# Access Compliance Report

## Public Rights-of-Way

### (Curb Ramps)

Intersection ID: 42726	Main Street: CAMPION_CT	Cross Street: PICKEREL_LN	Location:	N
ADA ID: 697F7A8B3CC8	Ramp Type: PerpDiag	Initial Pass/Fail: Fail	Overall Compliance: No	Severity Score: 21.25
Codes/Mitigation Info/Possible Solution		Field Measurements/Component Compliance

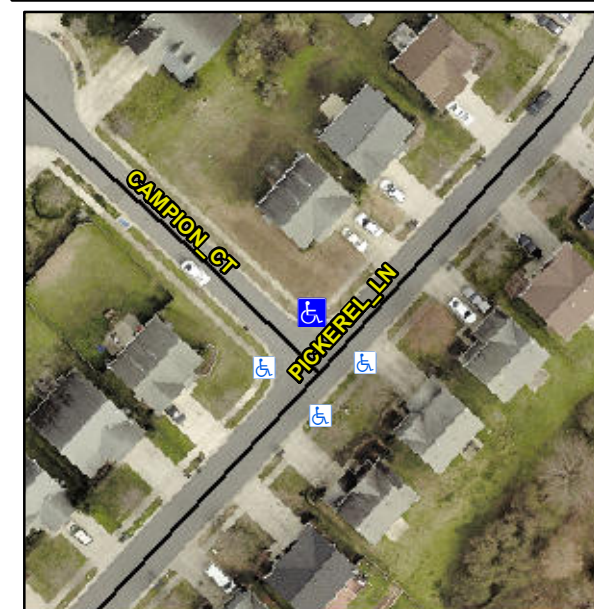
**Not Found, R304.5.1, R304.5.3**

Compliance	Description	Data	Compliance	Description	Data
N/A	Ramp Length (in)	47.0	Yes	Ramp Slope (%)	5.0
No	Ramp Width (in)	37.0	No	Ramp XSlope (%)	5.6
N/A	Flare Type LT	N/A	N/A	Flare Type RT	N/A
N/A	Flare Slope LT (%)	N/A	N/A	Flare Slope RT (%)	N/A
N/A	Flare Traversable LT?	N/A	N/A	Flare Traversable RT?	N/A
N/A	Landing Length (in)	N/A	N/A	DWS Provided?	N/A
N/A	Landing Width (in)	N/A	N/A	DWS Contrast?	N/A
N/A	Landing Slope (%)	N/A	N/A	DWS Length (in)	N/A
N/A	Landing X Slope (%)	N/A	N/A	DWS Full Width?	N/A
N/A	Landing Curb? (Y/N)	N/A	N/A	DWS Offset (in)	N/A
N/A	Shared Landing?	N/A			
N/A	Gutter Ponding?	N/A	N/A	Gutter Slope (%)	N/A
N/A	Gutter Lip Ht (in)	N/A	N/A	Gutter X Slope (%)	N/A
N/A	Painted X Walk1?	No	N/A	Painted X Walk2?	No
	X Walk 1 Direction	To SW		X Walk 2 Direction	To SE
N/A	X Walk 1 Width (in)	N/A	N/A	X Walk 2 Width (in)	N/A
	X Walk 1 Slope (%)	8.2		X Walk 2 Slope (%)	5.4
	X Walk 1 X Slope (%)	1.5		X Walk 2 X Slope (%)	0.1

**Remove & Replace Curb Ramp With Two New Directional Ramps or Equivalent.**
